## Process Sheet

<b>Customer</b>	: CU-DAR001 Dart Helicopters Services	<b>Drawing Name</b>	: BASKET RIB
<b>Job Number</b>	: 46305		
<b>Estimate Number</b>	: 10404		
<b>P.O. Number</b>	:	<b>Part Number</b>	: D31663
<b>This Issue</b>	: 05/03/2009	<b>S.O. No.</b>	:
<b>Prsht Rev.</b>	: NC	<b>Drawing Number</b>	: D3166 REV A2
<b>First Issue</b>	: / /	<b>Project Number</b>	: N/A
<b>Previous Run</b>	: 45941	<b>Drawing Revision</b>	: A2
	<b>Type</b> : LARGE FAB ASSY	<b>Material</b>	:
<b>Written By</b>	:	<b>Due Date</b>	: 11/03/2009
<b>Checked &amp; Approved By</b>	: <u>JUD 09.03.05</u>	<b>Qty:</b>	6 Um: Each
<b>Comment</b>	: Est. A 02.08.23 New issue KJ Est Rev:B 09-01-23 as per DEO D3166-A2 DD verified by:EC

DRAWING NO. D3166	TITLE BASKET HOOP	REV.A1	DART AEROSPACE LTD ENGINEERING ORDER		D.E.O. NO. D3166-A-2	SHEET NO. 1 OF 1	SCALE NTS
DRAWN AJS	CHECKED <i>[Signature]</i>	MFG. APPR. <i>[Signature]</i>	APPROVED <i>[Signature]</i>		DE APPR. <i>[Signature]</i>		
DATE 08.12.11	DATE 08.12.15	DATE 08/12/15	DATE 08/12/16		DATE 08.12.16

D3166-1 BASKET HOOP

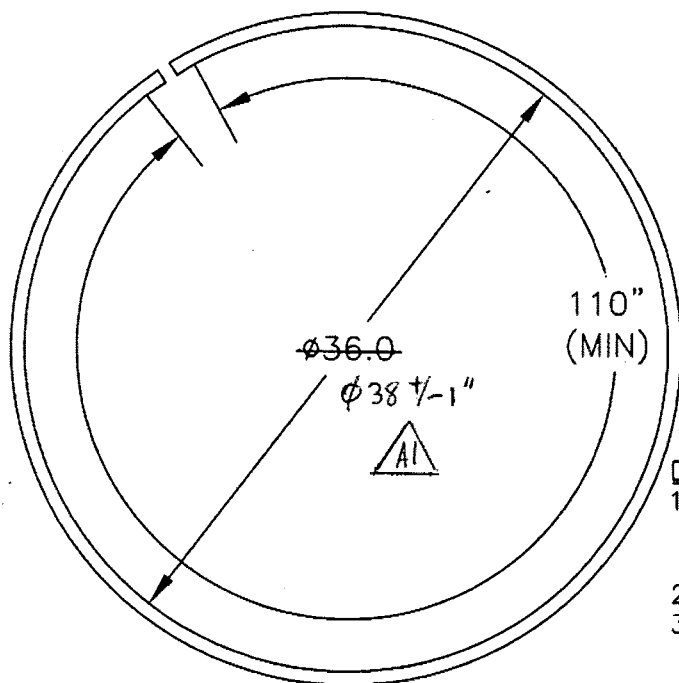
1) MODIFY MATERIAL NOTE FOR D3166-1 AS SHOWN:

2) MODIFY MATERIAL NOTE FOR D3166-3 AS SHOWN:

REASON: SEE PAR 08-005

1) MATERIAL: AISI 304/316 SS, 3/4 X 3/4 X 0.065 WALL SQUARE TUBING,  
60.00" LONG  
REF. DART SPEC M304TS0.750W.065

1) MATERIAL: AISI 304/316 SS, 3/4 X 3/4 X 0.065 WALL SQUARE TUBING,  
120.00" LONG  
REF. DART SPEC M304TS0.750W.065
